ADDENDUM NO. 1

**HANOVER COMMUNITY SCHOOL CORPORATION - NEW RESOURCE
CENTER AND RELATED WORK
Cedar Lake, IN 46303**

This Addendum consists of page ADD 1-1 and attached Addendum No. 1 from Gibraltar Design dated May 27, 2021 and consisting of 5 pages and 48 drawings.

M-101

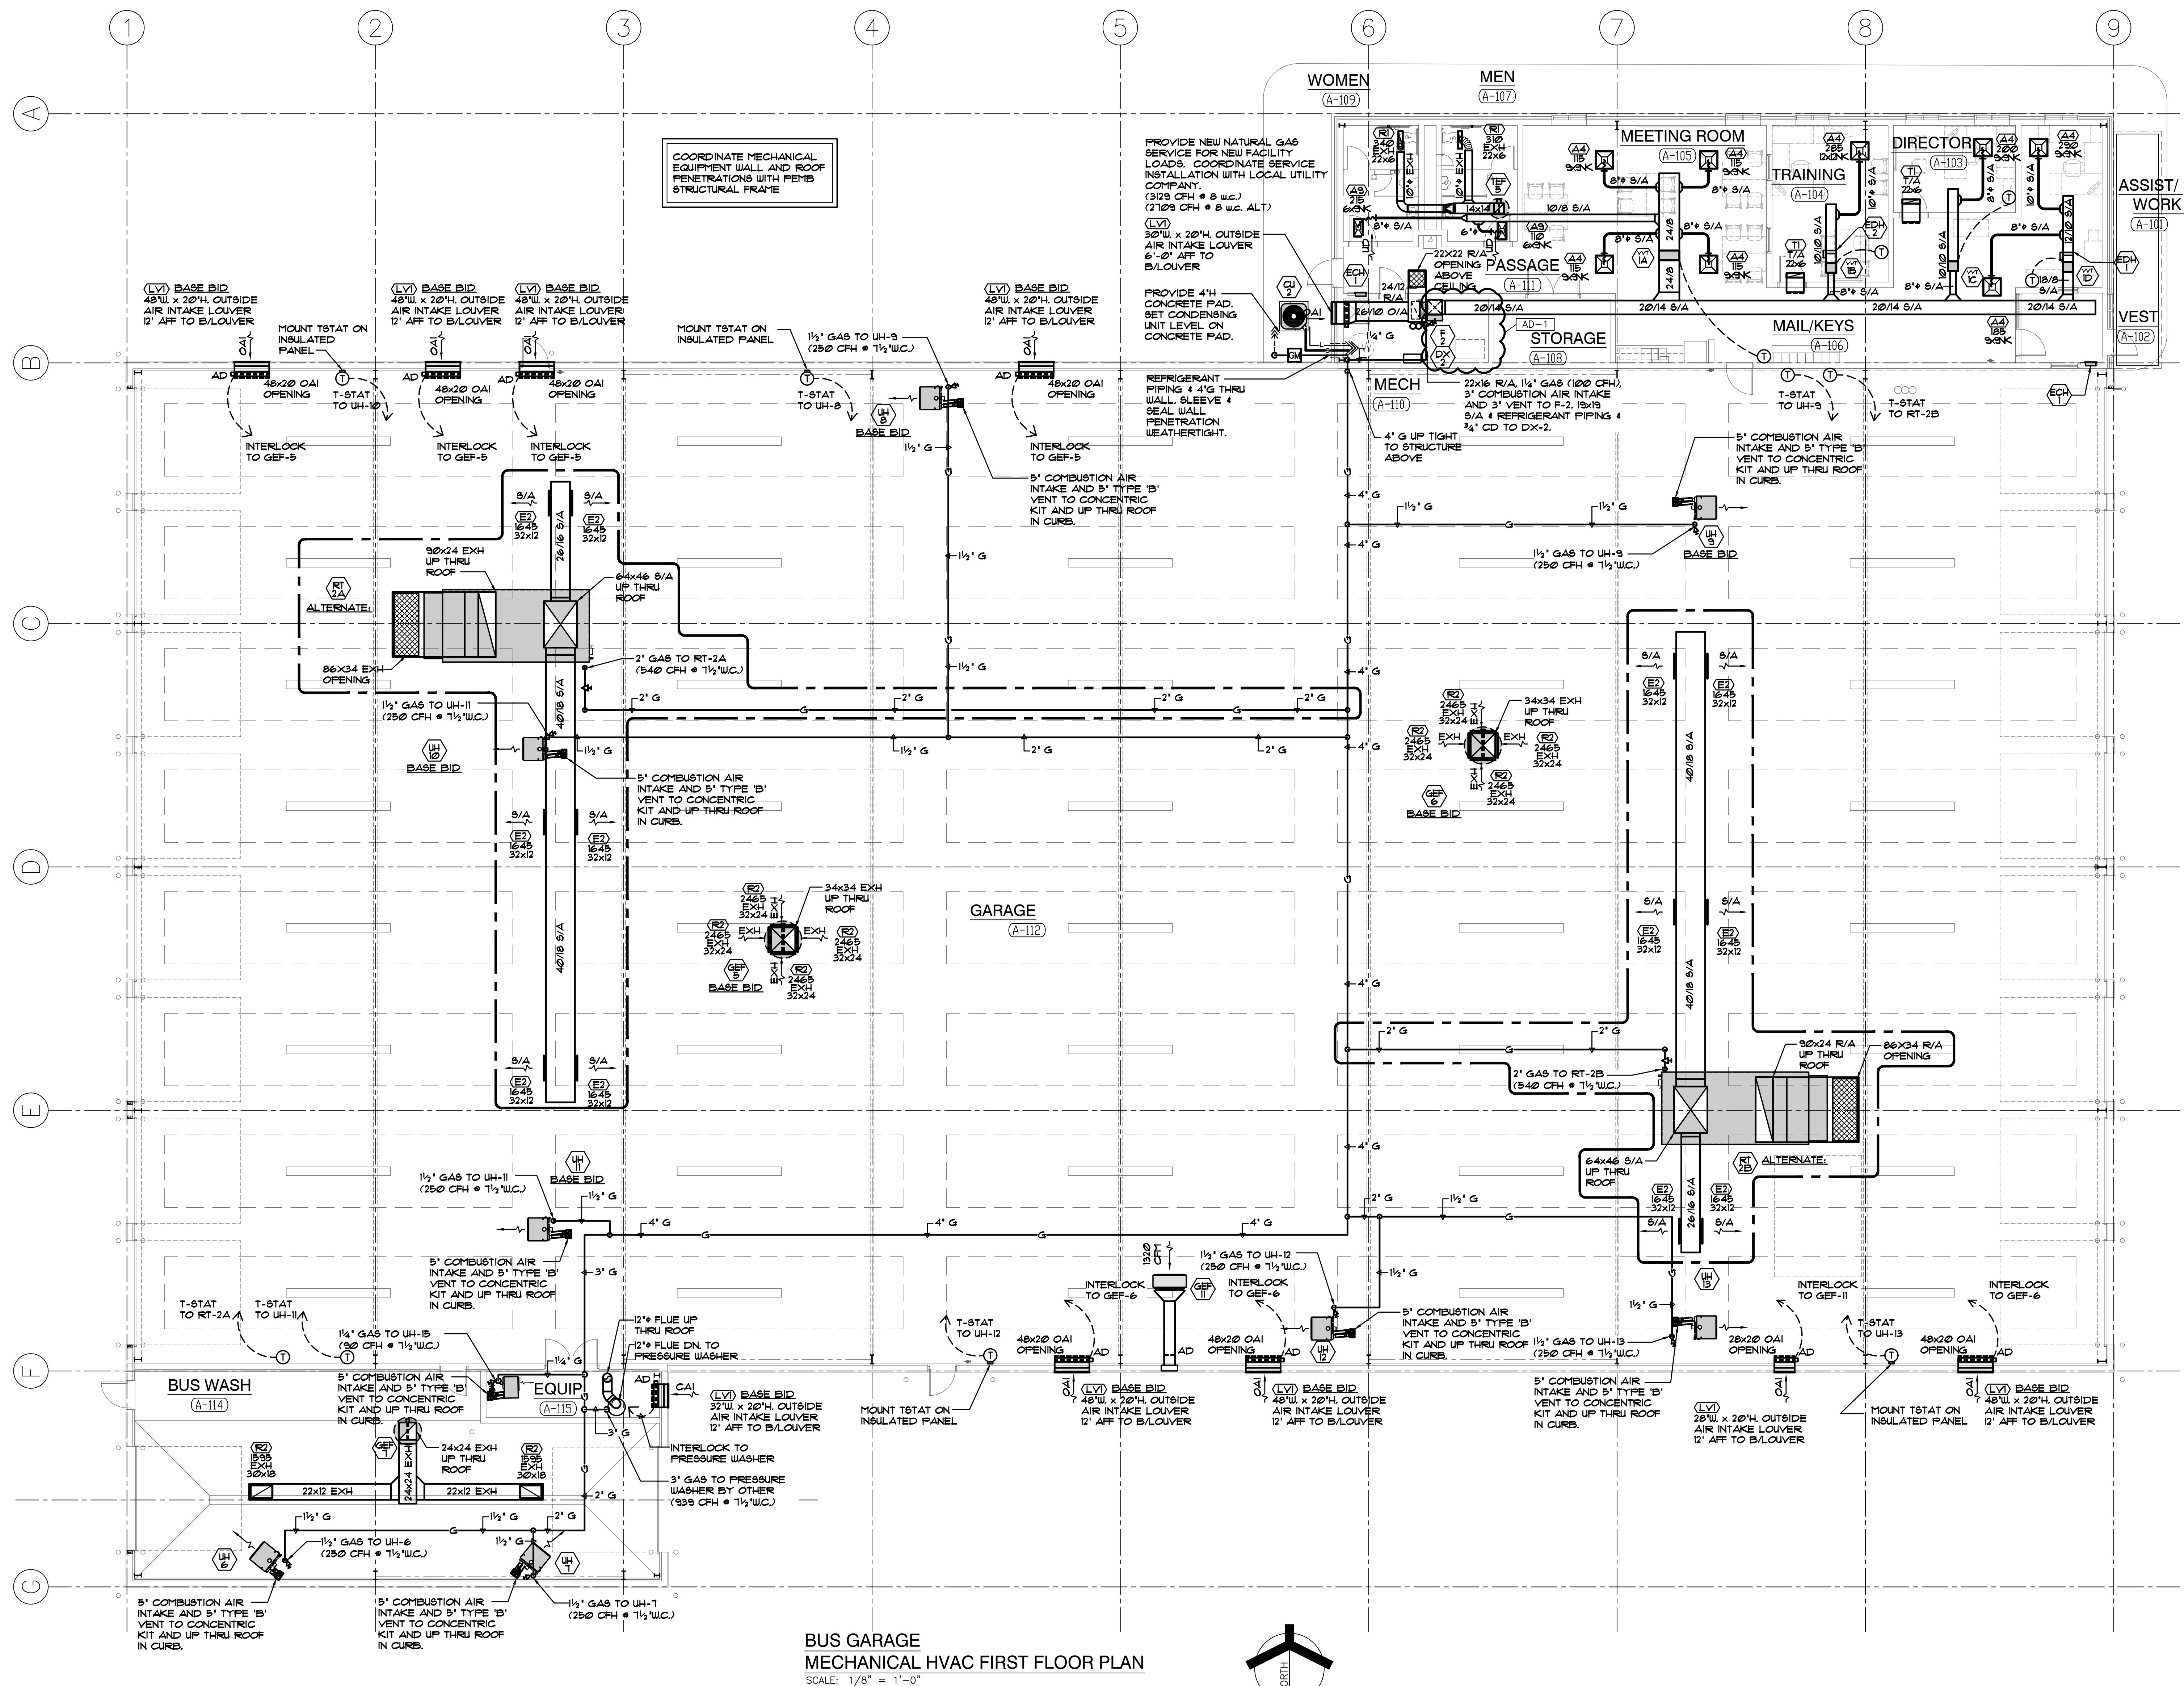
23. Sheet M-101

- A. REVISED floor plan per wall change. Refer to revised drawing for additional information.

EL101

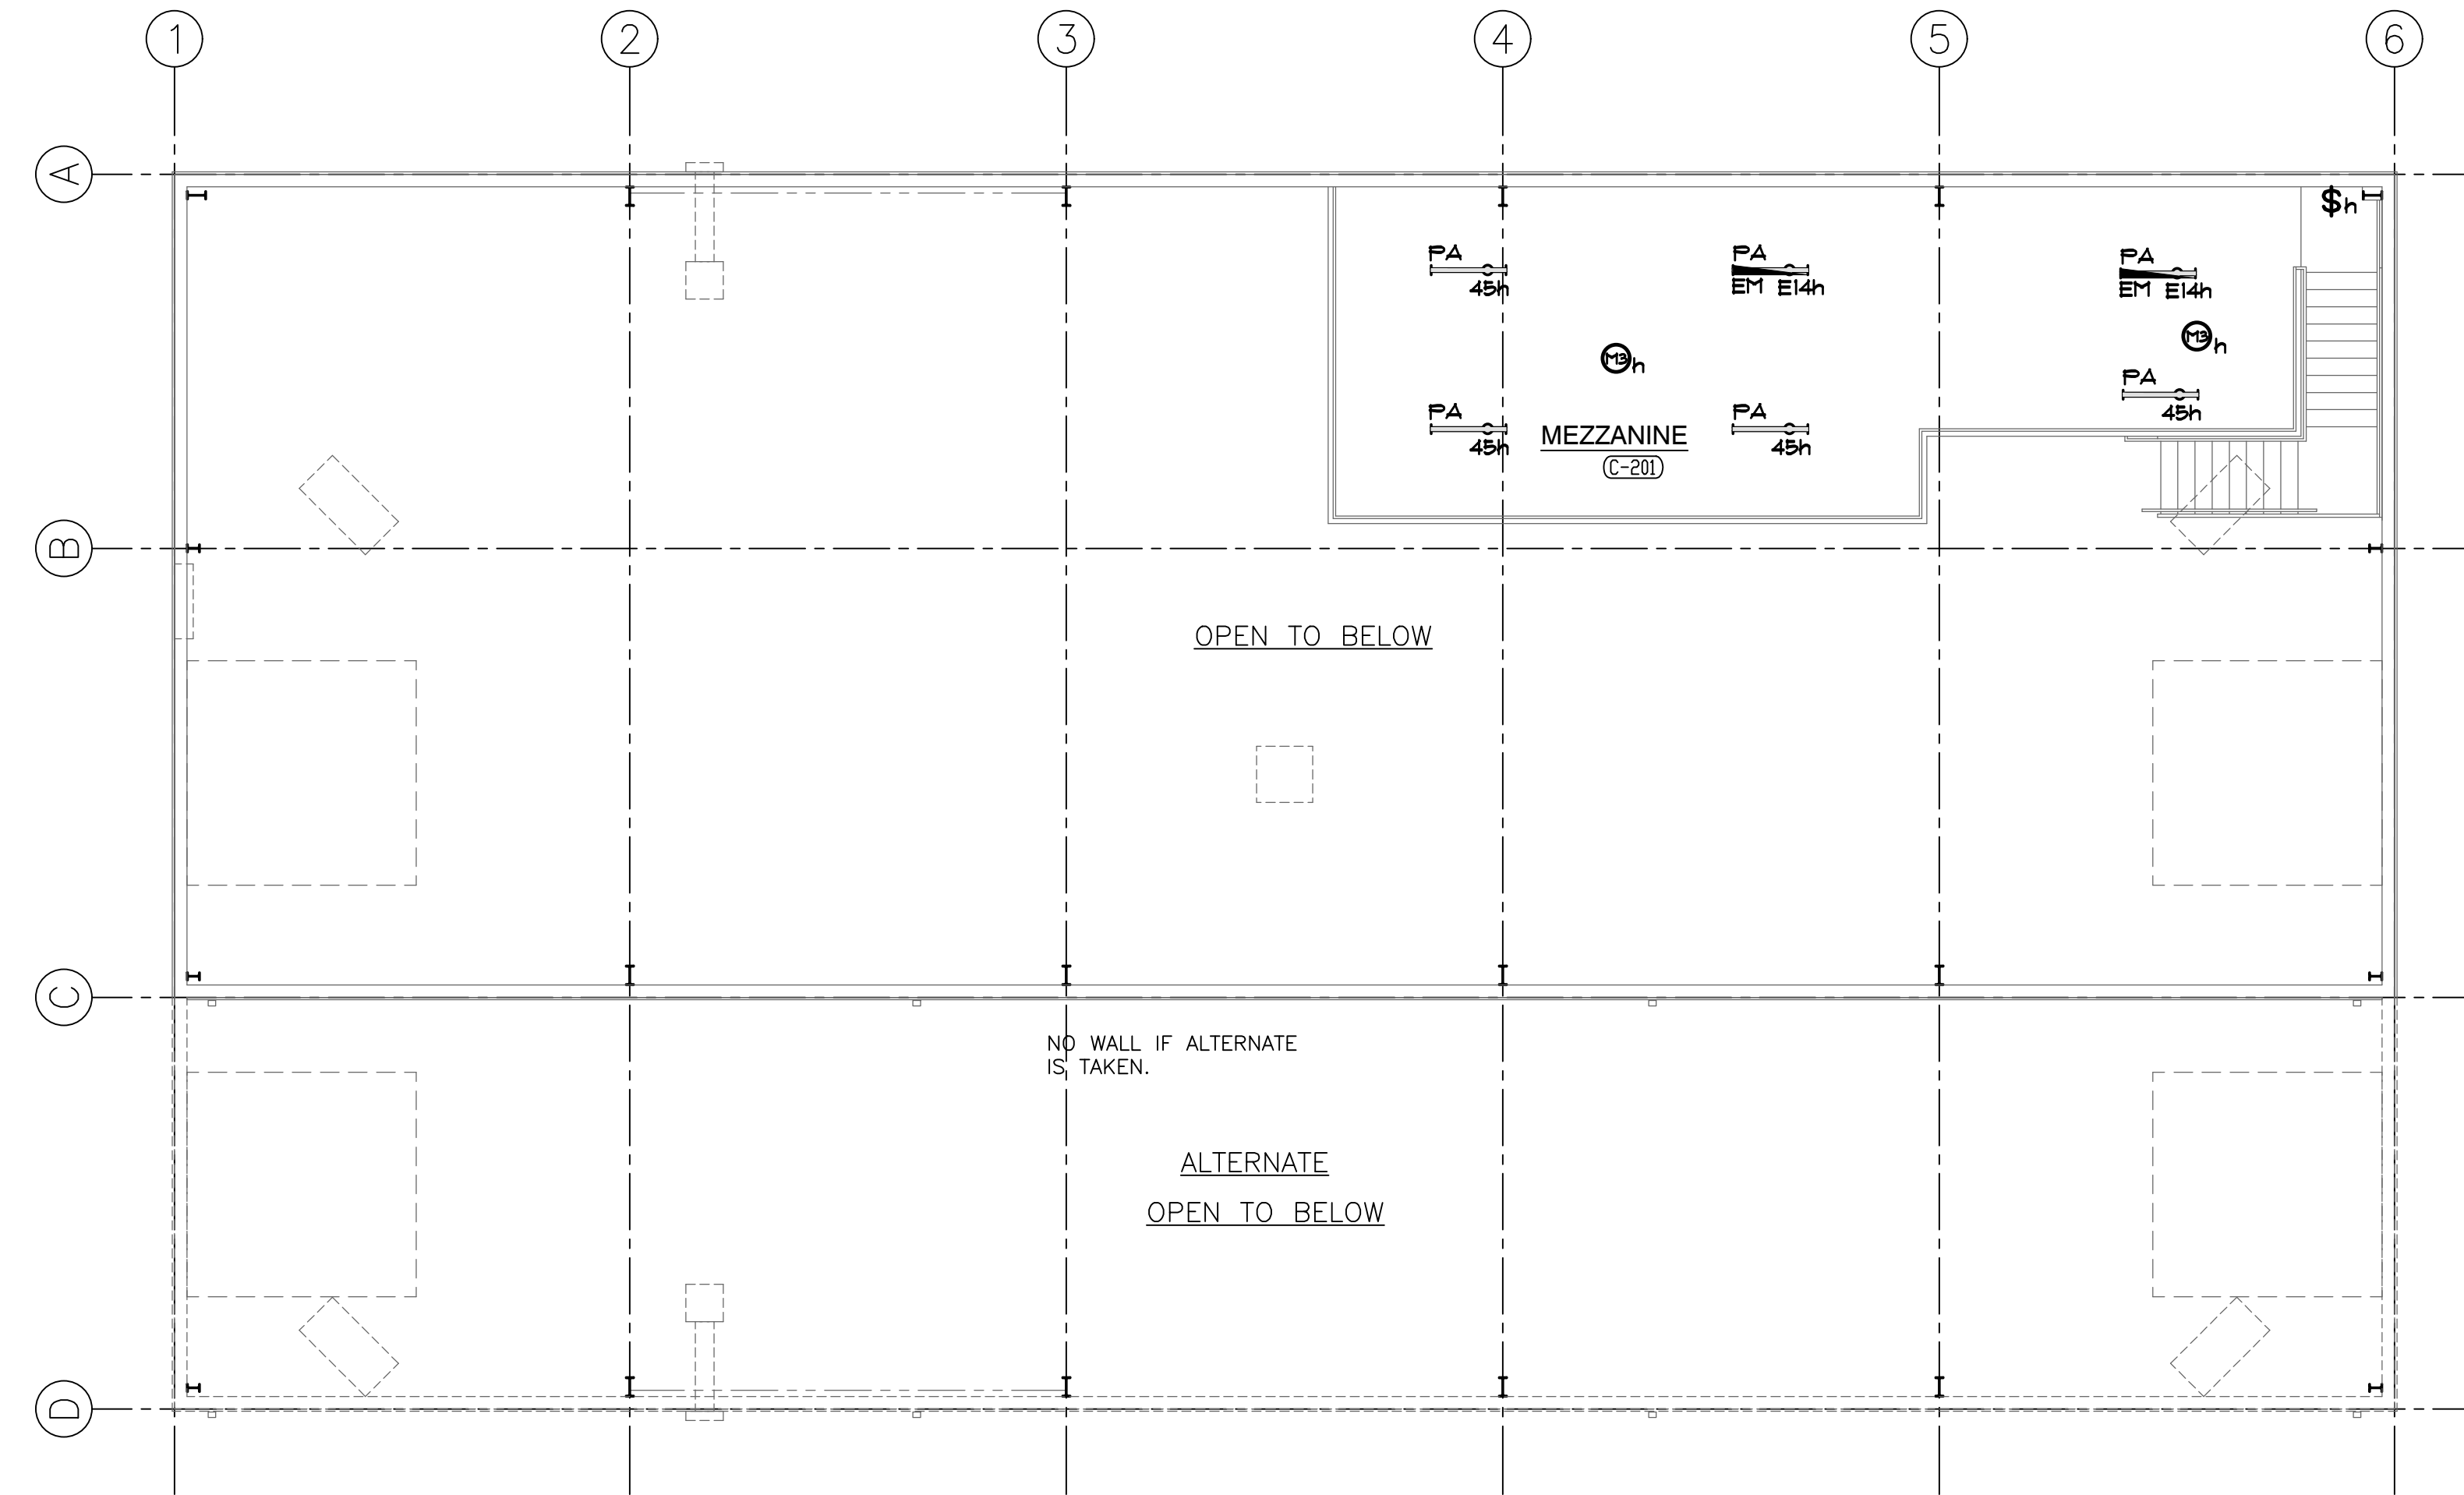
27. Sheet EL-101

- A. REVISE lighting quantities, locations and circuiting. Refer to revised drawing for additional information.

© GIBRALTAR DESIGN
SHEET
EL104

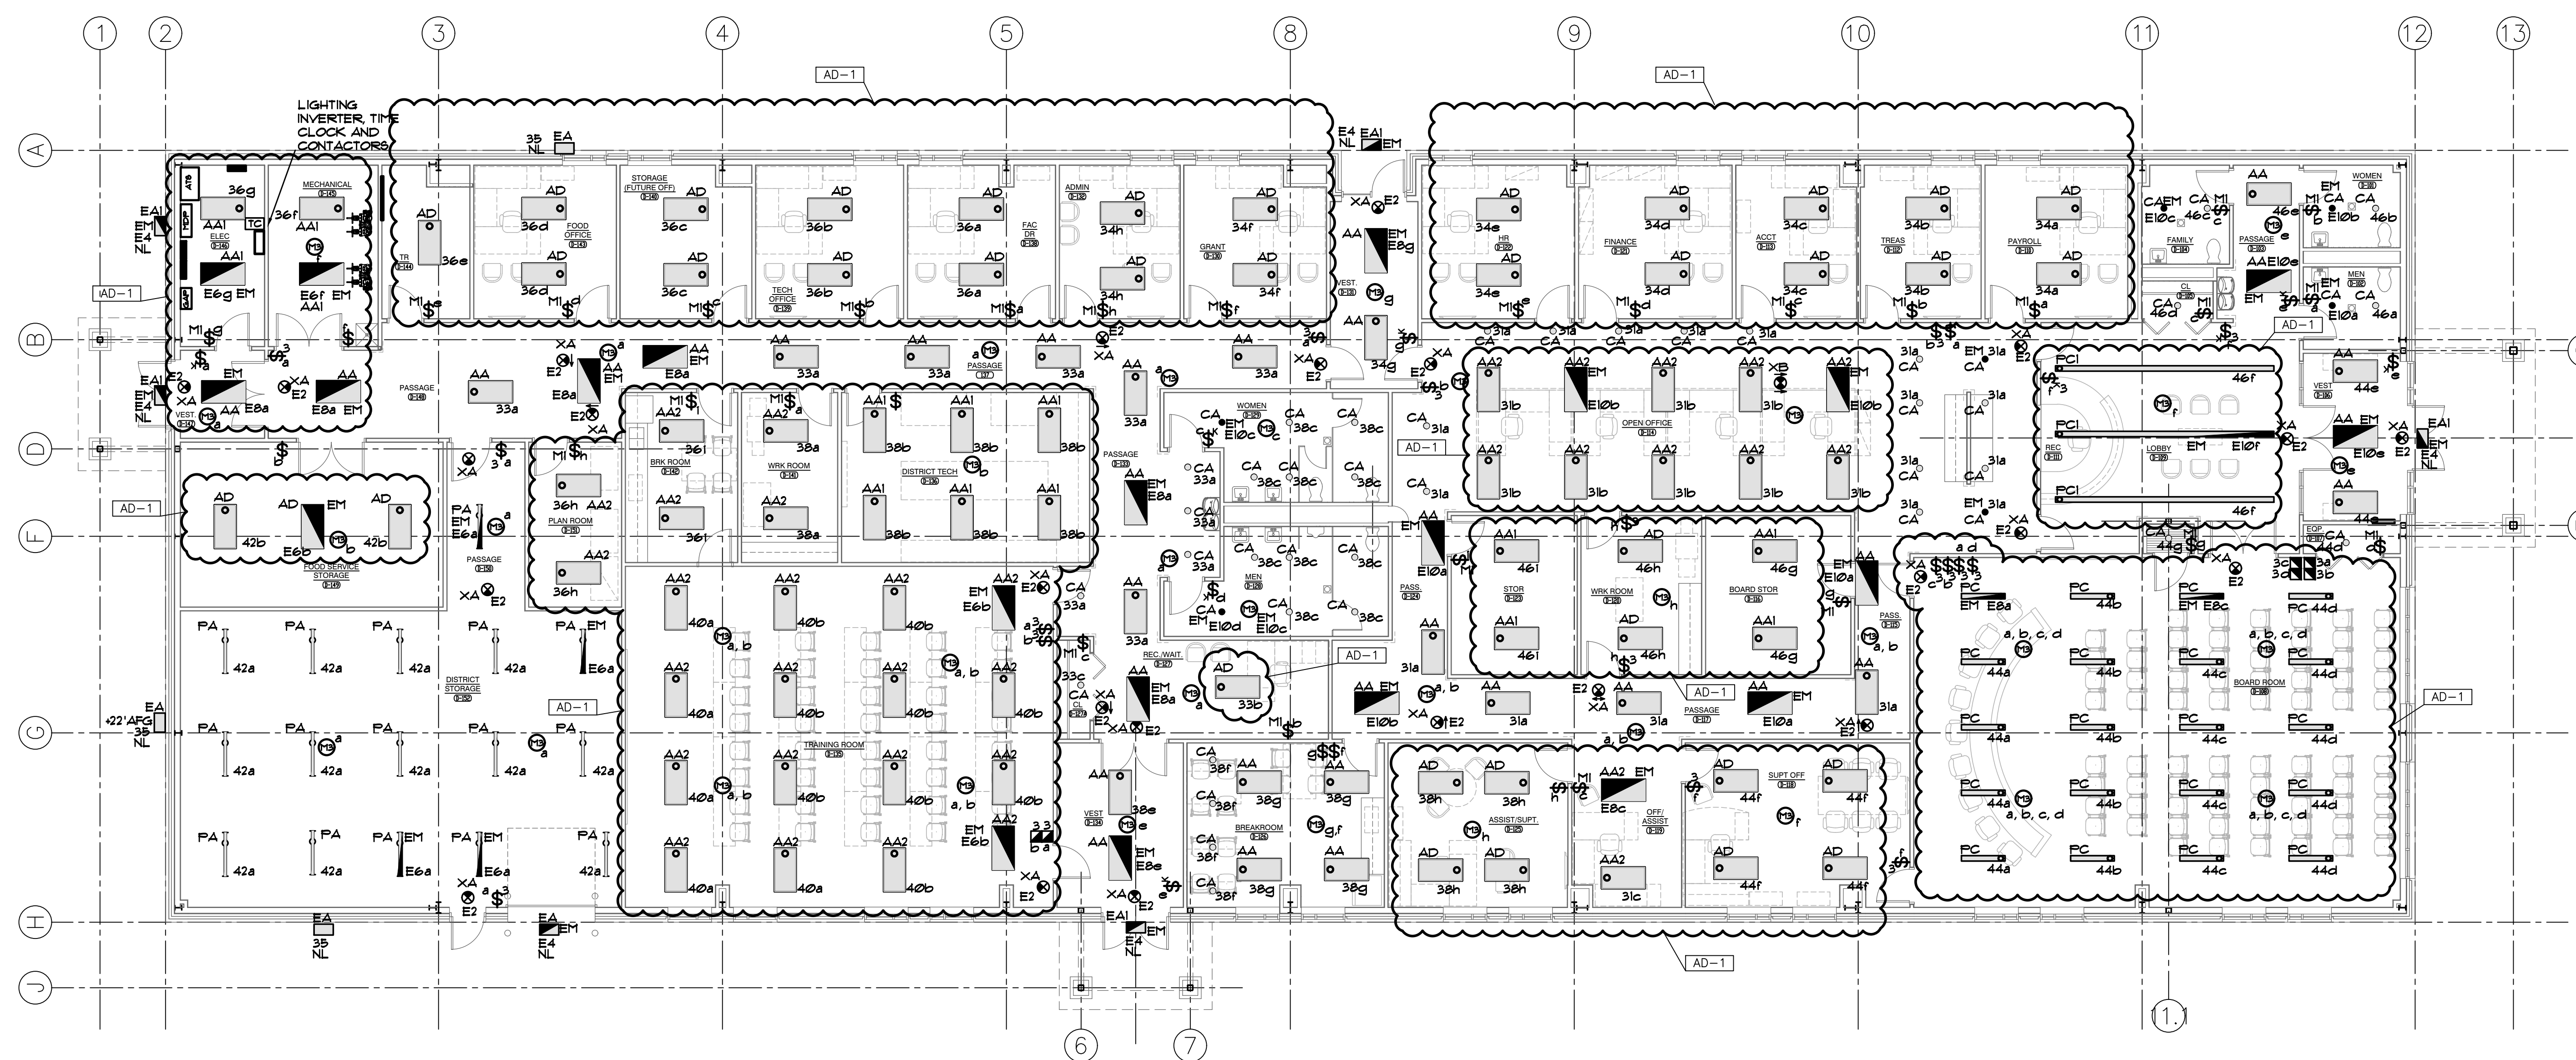
30. Sheet EL-104

- A. REVISE lighting quantities, locations and circuiting. Refer to revised drawing for additional information.
